CHENNAI METRO RAIL PROJECT PHASE 1 EXTENSION

BIDDING FOR CMRL-PS&OHE-04-2018

Addendum - II

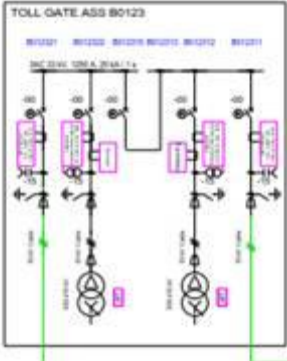
VI-ER 6.1 Pg.no 355 of 894	This section is dealing with Power Supply system and overhead equipment design requirement. Regarding all transformer supply for this contract, power losses are a real concern. As long 33kv cable network is the running throughout the entire line of the Phase 1 Extension under contract The Power factors and harmonics aspect shall also be taken care during construction phase/idle charging condition.	This section is dealing with Power Supply system and overhead equipment design and technical requirement.....In Traction system Reliability & design part on wind speed and train speed is concerned.
VI-ER 6.3.4.1	Sub Sectioning and Paralleling Posts (SSP) At strategic intervals the OHE is Sub Sectioned by means of an insulated	Add "(Type 1 @ SWA)" in heading
